Subject: Duke Energy Carolinas, LLC (Duke)
William States Lee III Nuclear Station - Docket Nos. 52-018 and 52-019
AP1000 Combined License Application for the
William States Lee III Nuclear Station Units 1 and 2
Response to Request for Additional Information (RAI No. 4870)
Ltr # WLG2010.09-09

Lee Nuclear Station Response to Request for Additional Information (RAI)

RAI Letter No. 091

Reference NRC RAI Number(s): 02.04.12-019

Figure 1
Ground Cover Within the Power Block and Surrounding Area

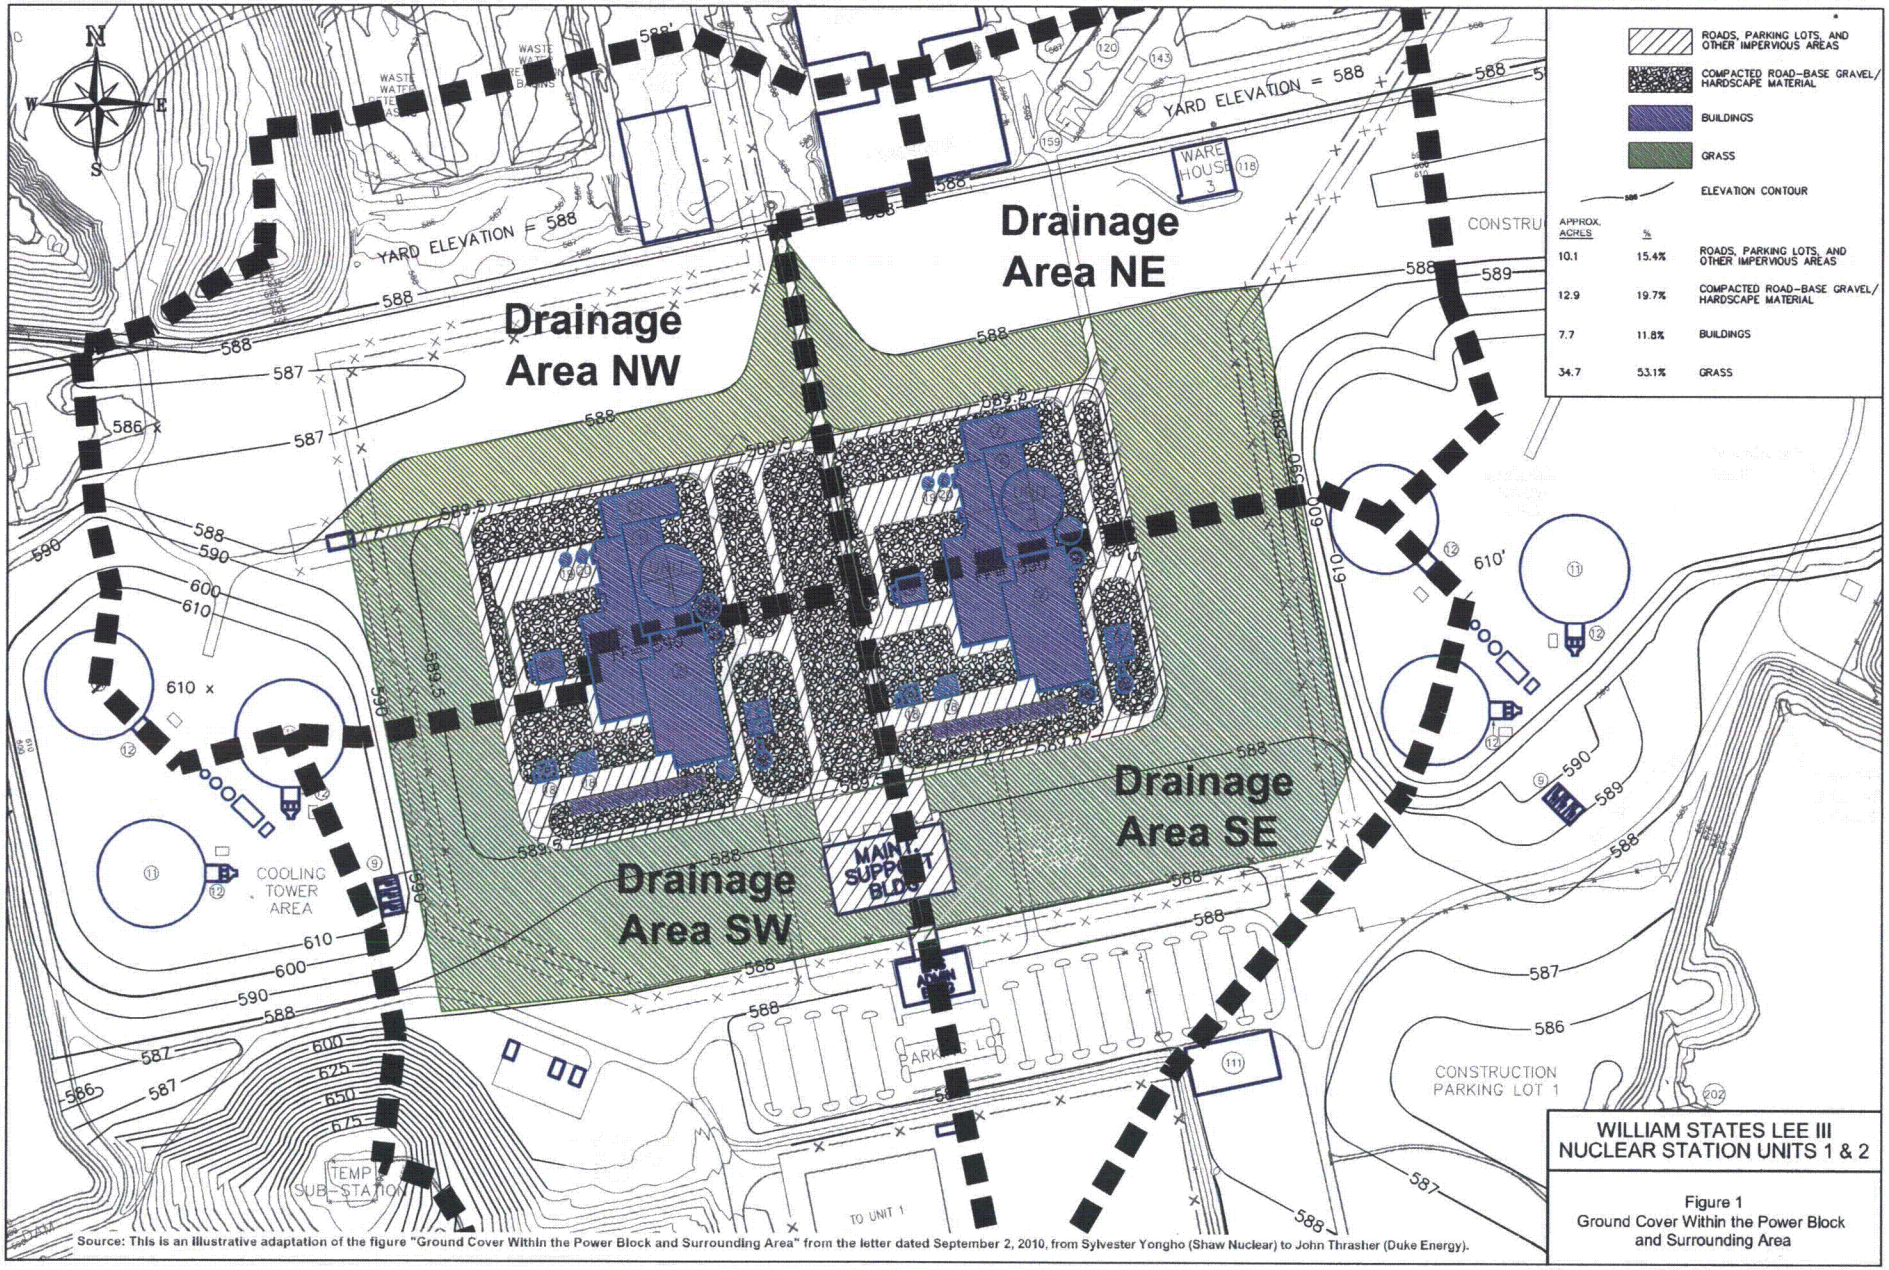
1) A conceptual description of the post-construction groundwater flow system,
2) Figures or GIS coverage showing the major surface features that may affect recharge within the key area, such as areas of different kinds of soil, vegetation, graveled surfaces, buildings, and paved areas, including percentages and locations,

6) A site grading plan of the key area with sufficiently-detailed elevation contours to show planned drainage features (e.g., swales; sub basins; drains).

1) A conceptual description of the post-construction groundwater flow system (Sections 1.0, 2.0, 3.0, and 7.0),
2) Figures or GIS coverage showing the major surface features that may affect recharge within the key area, such as areas of different kinds of soil, vegetation, graveled surfaces, buildings, and paved areas, including percentages and locations (Attachments 2 and 3, Figures 1 and 2),

6) A site grading plan of the key area with sufficiently-detailed elevation contours to show planned drainage features (e.g., swales; sub basins; drains) (Attachments 2 and 3, Figures 1 and 2, and Section 5.0),

approximately 65.4 acres, including 17.8 acres (27 %) of impervious surfaces (consisting of 10.1 acres of roadways, parking lots and other impervious areas and 7.7 acres of building footprints), and 12.9 acres (20 %) of semi-impervious compacted gravel (graded road base material consisting of gravel, sand, and silt) or otherwise hardscaped areas to promote runoff. Approximately 34.7 acres (53 %) of the 65.4-acre station will be grass surface cover (Attachment 2, Figure 1). Runoff coefficients for compacted gravel and hardscape surfaces (approximately 0.76 - 0.91) are much higher than those of a typical grass surface (approximately 0.15 - 0.35); therefore, the surface cover using compacted gravel will be expected to be much more conducive to run-off in comparison to grass surfaced areas.
